# ***Interactive comment on “Evaluations of an ocean bottom electro-magnetometer and preliminary results offshore NE Taiwan” by Ching-Ren Lin et al.***

Received and published: 15 August 2019

**Fig. 1.** Response of fluxgate

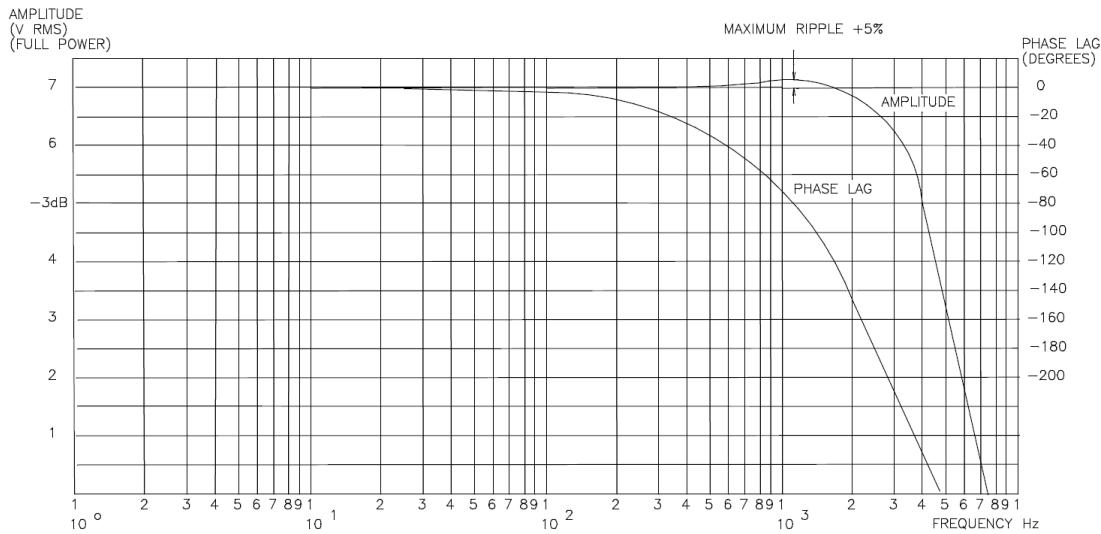
5. Calibration of fluxgate is one of the most important work for OBEM. What is the result for this evaluation?

Response: The fluxgate response of amplitude and phase shows in figure 1. Frequency of 0 to 1kHz maximally flat,  $\pm 5\%$  maximum at 1kHz. The details of the electrode, fluxgate, and amplifier have described in lines 85 - 92.
